August 25, 2005

SUBJECT: Response to Request for Additional Information dated August 5, 2005
Suwannee American Cement – Branford Plant
DEP File No. 1210465-014-AC (PSD-FL-352)
Proposed New Kiln at the Branford Cement Plant in Suwannee County, Florida

Aerial photograph of SAC and Immediate Surrounding Land Use

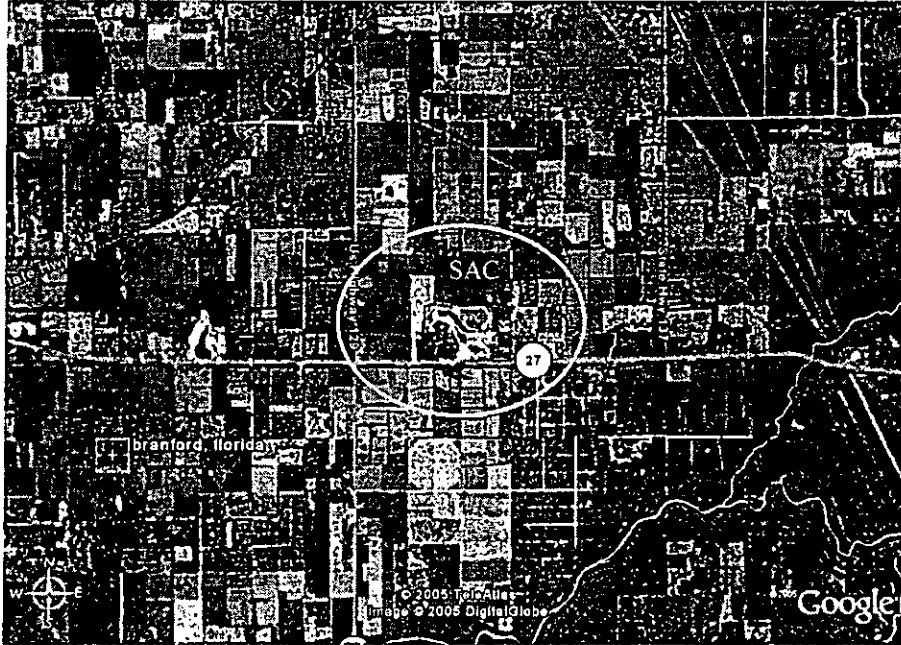
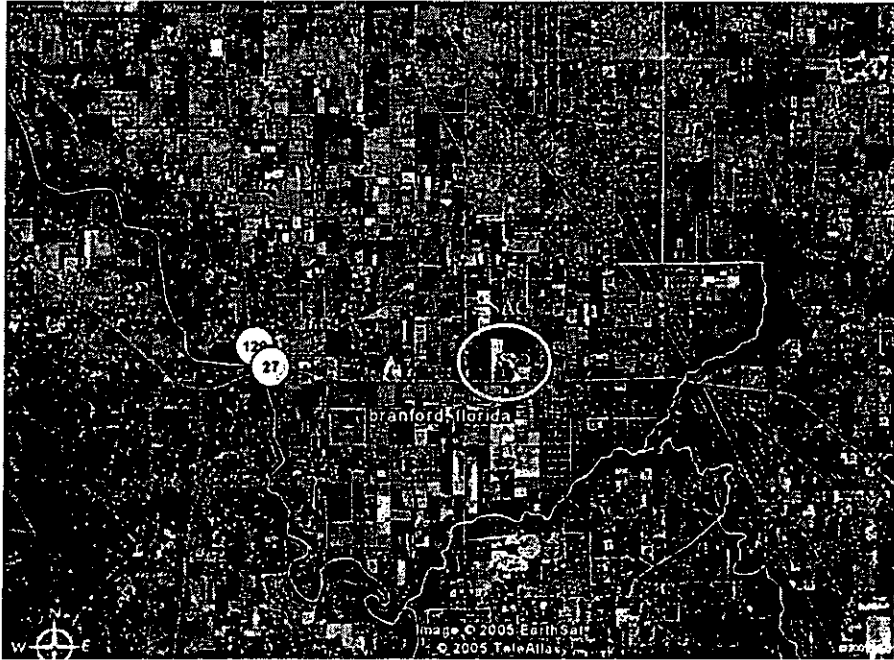
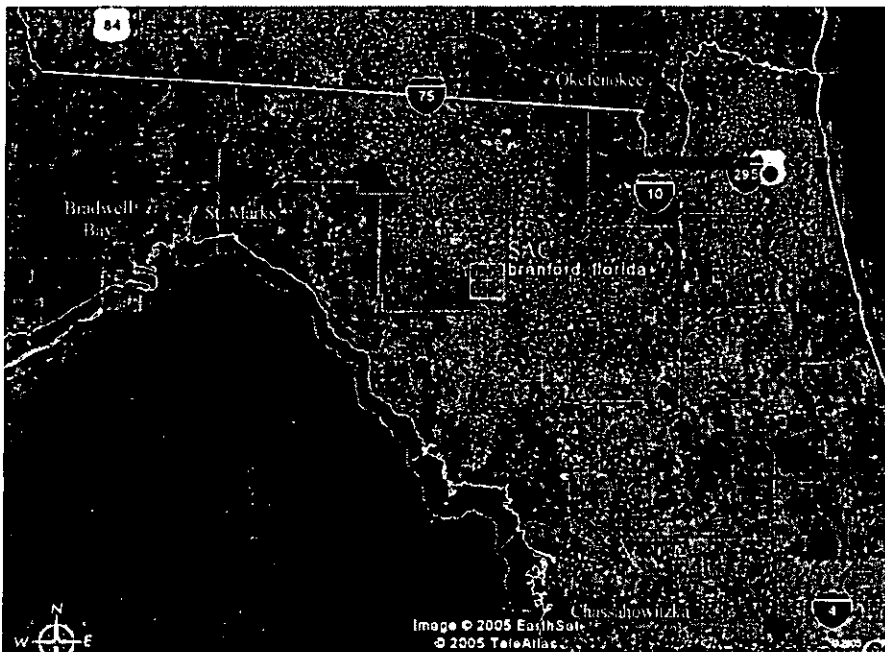
- c) *Constant monthly ammonia background concentrations of 0.5 ppb were input to Calpuff. This constant concentration is reflective of a forested area, as indicated in the final FLAG document, and is the recommended default value unless there is specific data available for the modeling domain. This notwithstanding, FLAG also specifies a default value of 10 ppb for grasslands. Since a value of 10 ppb was used in the June 2005 Class I modeling, and presuming no specific data are available for each Class I area, it is unclear why the background ammonia has changed. Given the importance of the background ammonia concentration towards chemical transformation and the creation of sulfates and nitrates, which are hygroscopic and have a profound impact on visibility and the percent change in extinction coefficients, SAC should justify choosing a default value of 0.5 ppb instead of 10 ppb. Such could be based on an analysis of the predominant land-use type (forest or grassland), as found within each Class I area.*

As stated in paragraph (a), the default background concentrations for ozone (80 ppb) and ammonia (10 ppb) were the original concentrations used in the Class I CALPUFF screening modeling discussed in Section 6 of the SAC report dated June 23, 2005. The 10 ppb ammonia concentration was the *default* background concentration used by the model and not the concentration recommended in IWAQM/FLAG and EarthTech guidance for the predominant land-use type, which consists of predominantly forested

areas. The background value for ammonia as recommended in both IWAQM/FLAG and EarthTech guidance for forested areas is 0.5 ppb, which is significantly lower than the default value of 10 ppb for grassland. Thus, based on available guidance pertaining to background ammonia concentrations, the SAC Class I screening analysis was revised and the results summarized in Section 6 of the SAC report dated July 27, 2005. This issue was also discussed with the FLM during a July 27, 2005 conference call between the FLM, SAC, and EQ at which time no objections were presented.

Additionally, not only the Class I Area has to be evaluated, but the entire path to the Class I from the source (SAC) should be evaluated, since this the path along which the chemical transformations take place. The land use in this area is consistent with forested areas, and not grasslands. Aerial photographs are provided below to show the land use coverage of the area.

Figure 6-1. Location of Class I Areas Relative to SAC

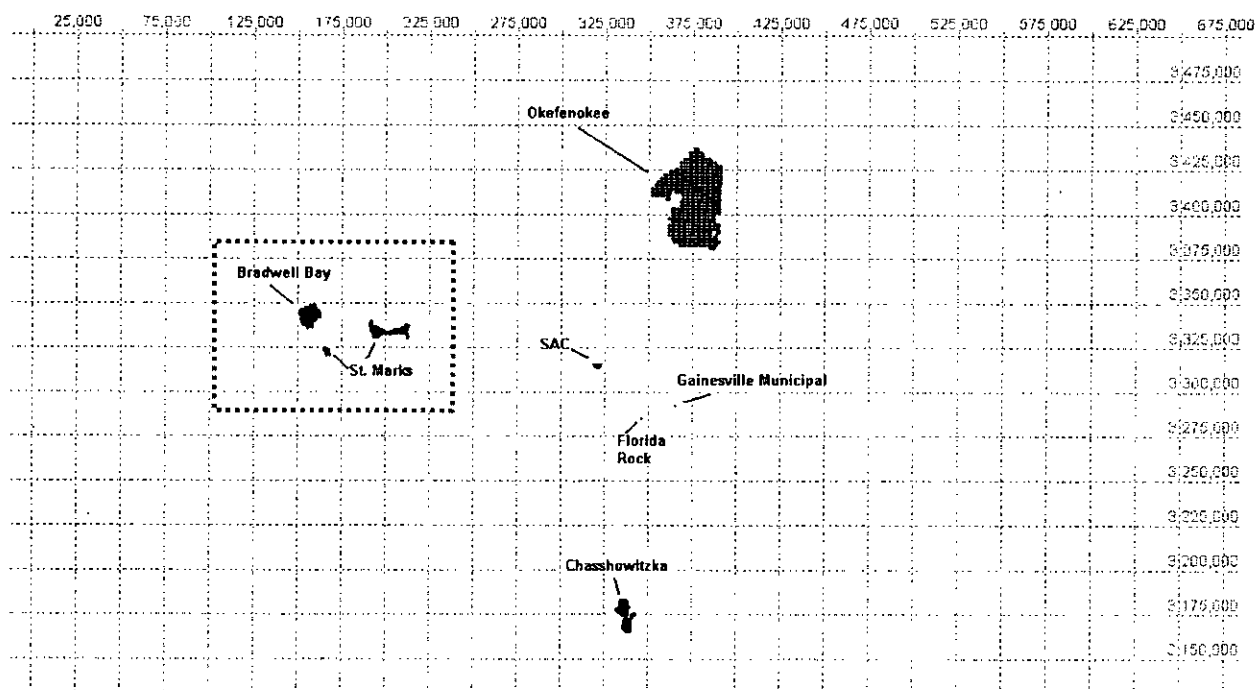
- e) *Table 2.B-1 of Appendix 2.B to the Final FLAG report does not contain relative humidity adjustment factor information for the Bradwell Bay Class I area. SAC instead used the seasonal information presented in Table 2.B-1 for the St. Marks Class I area. Please discuss why the St. Marks' data was used as a surrogate for Bradwell Bay.*

Because Table 2.B-1 of Appendix 2.B of the FLAG guidance did not contain relative humidity adjustment factor information for the Bradwell Bay Class I area, the information for the other Class I areas considered in the analysis for SAC was evaluated and used to develop the most appropriate substitute for the Bradwell Bay Class I area. Comparing the information summarized above from the FLAG guidance, the values for "Components of Dry Extinction" for all three Class I areas (Okefenokee, Chassahowitzka, and St. Marks) were exactly the same and values of f(RH) were very similar with respect to each other.

Therefore, due to the proximity of the Bradwell Bay Class I area to the other three Class I areas, the relative humidity adjustment factor information for the closest Class I area to Bradwell Bay was used for the CALPUFF-lite screening modeling for Bradwell Bay. The closest Class I area was St. Marks, which is approximately 30 km east of Bradwell Bay. Figure 6-1 (also shown below) from the July 27, 2005 SAC report shows the location of St. Marks with respect to Bradwell Bay as well as the locations of all Class I areas evaluated relative to SAC.

Supplemental Figure
Maximum Receptor Location for Visibility Impairment Analysis
at the Okefenokee Class I Area

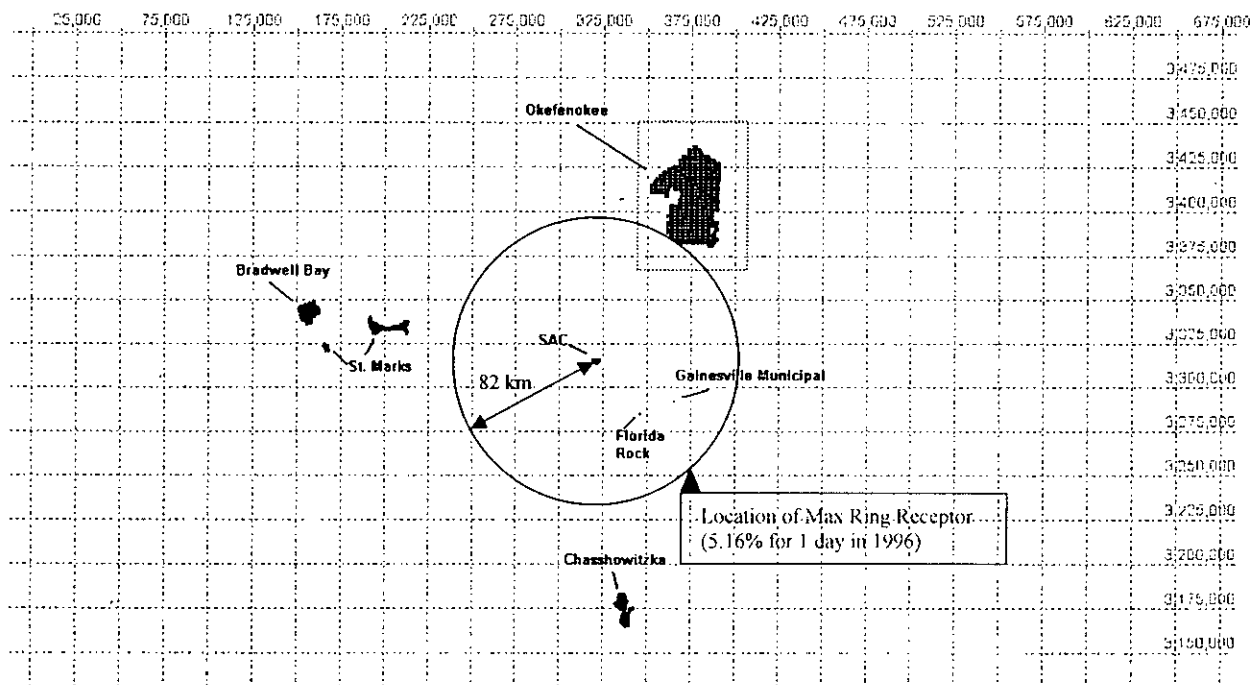
f) The final FLAG report suggests that a cumulative visibility analysis be conducted if a predicted percent change in extinction equals or exceeds 5%. An exceedance of the 5% threshold was predicted at the Okefenokee Class I area (5.16%). Instead of conducting the suggested cumulative analysis, SAC isolated the Class I area receptors at Okefenokee and re-ran Calpuff only at the Class I area receptors (previous, the analysis was conducted using the FLAG recommended ring of receptors). The results were shown to be less than 5% using this limited receptor grid. The IWAQM Phase 2 final recommendations warn against the use of this type of limited receptor grid as input to screening modeling. Why was this method used to refine visibility impacts? Consider completing the ring of receptors recommended by the FLAG report for determining the maximum impact on visibility in the Class I area.

SAC did complete the visibility analysis using the ring of receptors as recommended by the FLAG report for determining the maximum impact on visibility in the Okefenokee Class I area (as well as the other three Class I areas – Chassahowitzka, St. Marks and Bradwell Bay). Based on the results of the ring analysis (shown in Table 6-5 of the July 27, 2005 SAC report), there was one year (1996) during which one day (Julian Day 365) showed a maximum percent change in extinction coefficient just slightly greater than 5.0% (5.16%). This occurred at the Okefenokee Class I area. Okefenokee is located 82 km northeast of SAC between 16 and 46 degrees (0 degrees being north). This maximum value (5.16%) occurred on the ring at 138 degrees, which is more than 90 degrees away (along the ring) from the actual location of Okefenokee (refer to the supplemental figure below).

Because the only visibility impairment occurred at a location remote to Okefenokee, an additional analysis (in addition to the ring of receptors) was performed to evaluate the specific receptors that comprise the Okefenokee Class I area. These receptors were obtained from the National Park Service, Air Resources Division (ARD). These receptors were subsequently modeled independently to evaluate the visibility impacts, using the same methodology as previously completed for the ring of receptors. The results of this analysis are presented in Table 6-6 of the SAC report dated July 27, 2005. The results show that for the specific Okefenokee Class I receptors, the increased SAC emissions have a visibility impairment of less than 5.0 % over a 24-hour period for each year and that the maximum impact for 1996 was well below 5.0% (1.55%). Thus, the visibility impact analysis for these Class I areas using the CALPUFF-lite modeling methodology demonstrated that the impacts on this Class I area were less than

the FLAG recommended evaluation criterion of a 5 percent change over the natural background extinction. This additional analysis was provided as supplemental information for discussions with the FLM. The intent was to show that there was only one day where the modeled maximum percent change in extinction coefficient was slightly greater than 5.0% and occurred at a ring receptor not in the vicinity of the Okefenokee Class I area.

FIGURE 1. EXISTING AND NEW PLANT ROAD LOCATIONS AND SHAPES BASED ON THE ISC MODEL INPUT DATA COORDINATES

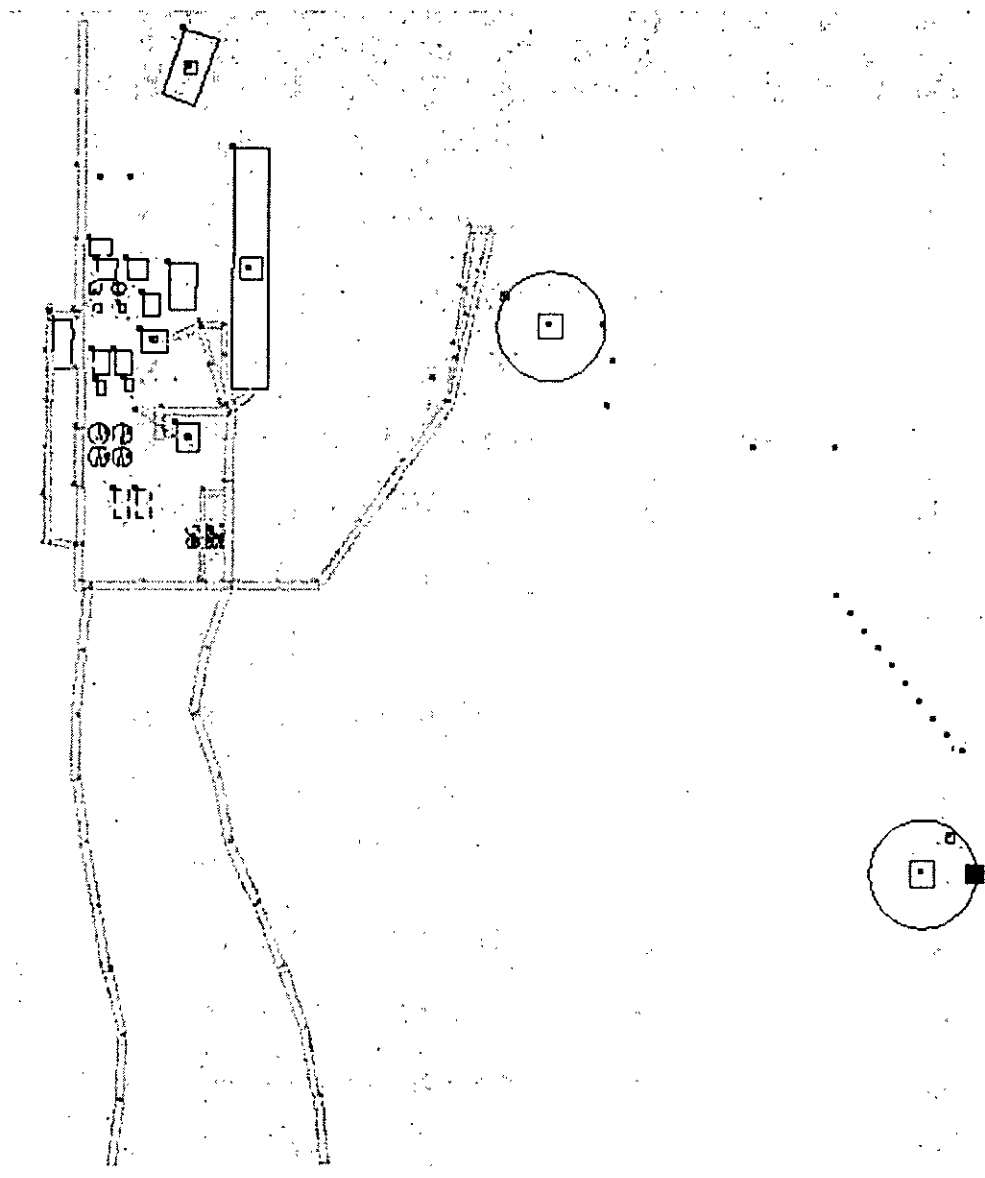
Also, we compared the Existing and New plant road locations and shapes based on the ISC Model input data coordinates with those based on the plant site map provided by SAC. Figure 1 shows the plant road locations and shapes based on the ISC Model input data coordinates. The plant site map indicates that the Existing Road forks into an eastern and western branch before merging again at the plant fence line. However, the Existing Road based in the ISC Model coordinates has no fork. Possibly, the trucks do not travel on the western fork of the Existing Road.

Conclusion: Recheck all point and area source coordinates used in the modeling study to determine their accuracy and provide corrected coordinate information to the Department. Confirm the actual truck traffic patterns on the western and eastern forks of the Existing Road.

Response: The model inputs for the point sources have been verified and the modeling input files and report provided to the Department contained the correct coordinates. The oversized maps requested by the Department and provided to the Department in July incorrectly located the reference coordinate. The reference point should have displayed the coordinates of 321243.75 Easting, 3315195.69 Northing. Revised facility layout and area maps are attached with the correct coordinates shown.

The new oversized map labeled Facility Layout attached provides the correct coordinate reference point and overlays correctly with coordinates used in the modeling input files. Traffic patterns have been correctly identified in the modeling for the Existing Road.
